SYDNEY HARBOUR ASSOCIATION

DA0136/12, Rose Bay Marina, Rose Bay

ROSE BAY MARINA GEN C. P.A. PROPOSED 2012.
 IMPACT OF TIDAL VARIATION ON VIEWS OVER
 THE PROPOSED, SUGGESTED MODIFICATIONS,

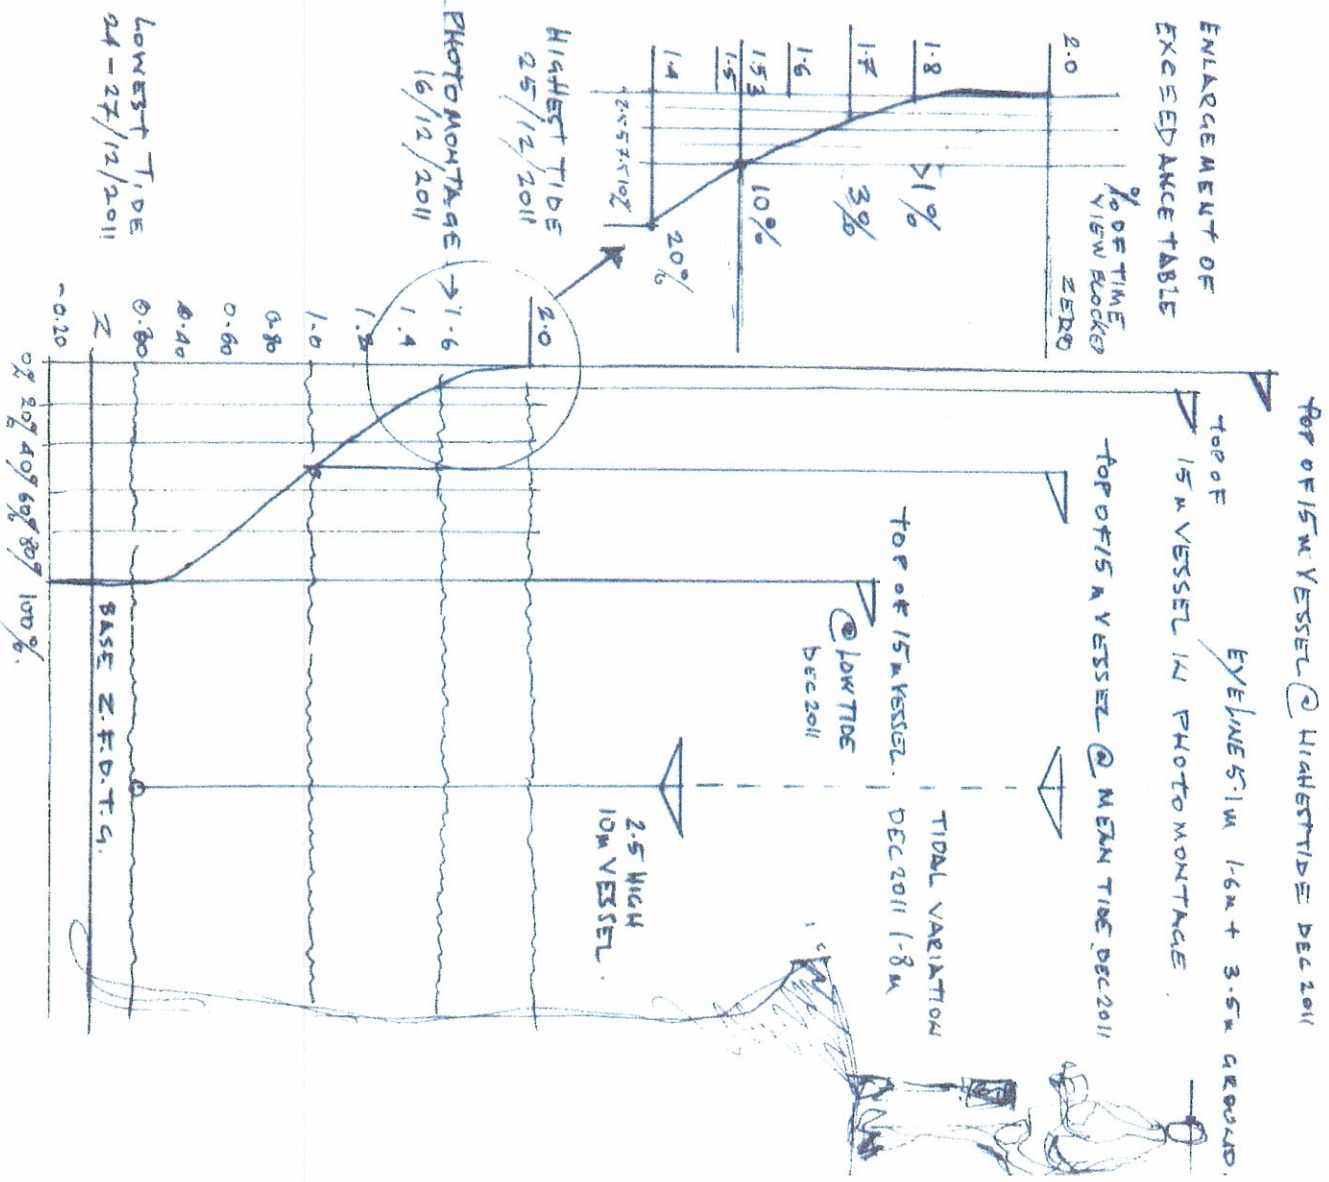
If our modifications are adopted, people using the Rose Bay Promenade will have *clearwater* views to North Harbour for some 30 per cent of the 290 metres of the relevant Promenade length that provides views to North Harbour.

Attachment C shows the extent of the *clearwater* views from the Rose Bay Promenade that could be available to the public if our modifications were adopted.

TIDAL EXCEEDANCE TABLE @ FORT DENISON TIDAL.
 GAUGE DURING DECEMBER 2011.
 ATTACHMENT A.

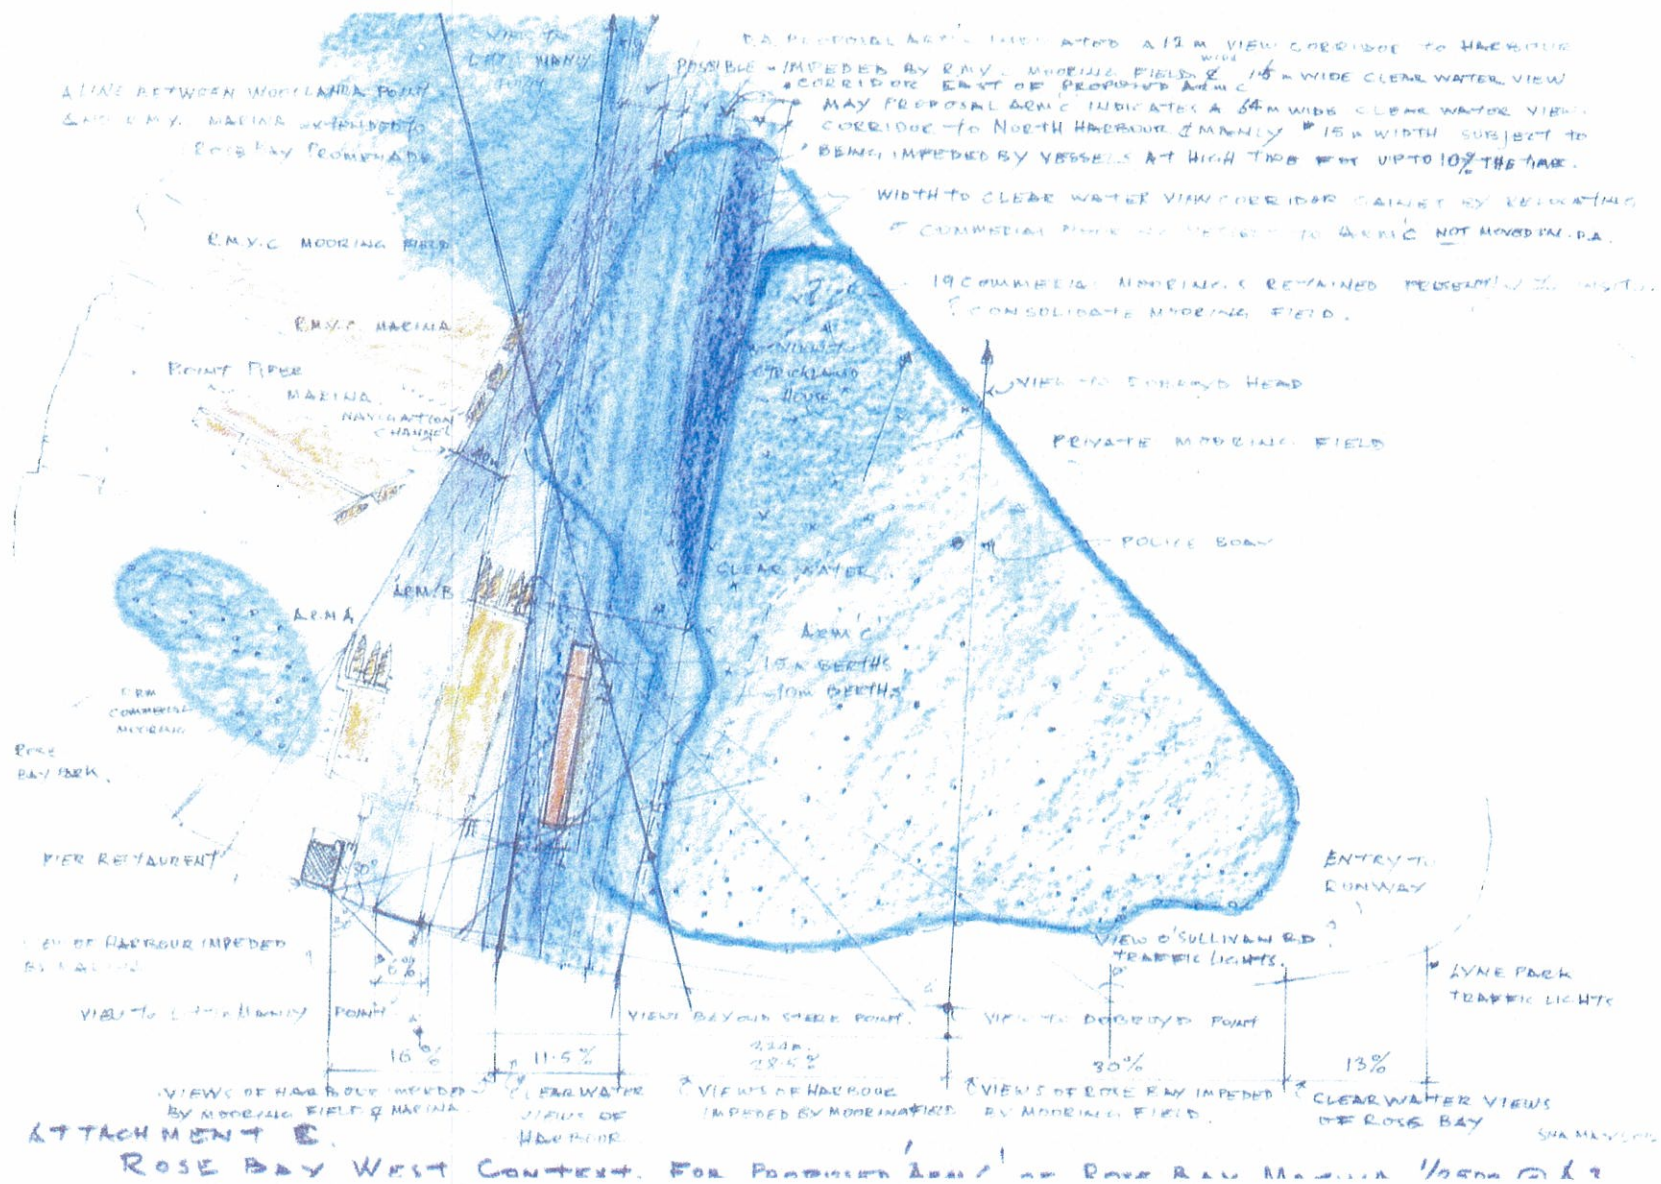
The EIS for this DA fails to acknowledge the full extent to which vessels moored on the new arm would block Harbour views from the Promenade.

Attachment A sets out our understanding of the situation proposed in the DA. It shows that for approximately 10 per cent of the time, the views towards Manly (and the Rose Bay+ eastward shores) would be blocked by 15-metre vessels berthed at or about the outer limit of the new arm and riding on a tide of 1.6 metres. However higher tides would block views for a lesser proportion of time, because the upper levels are shorter in duration.
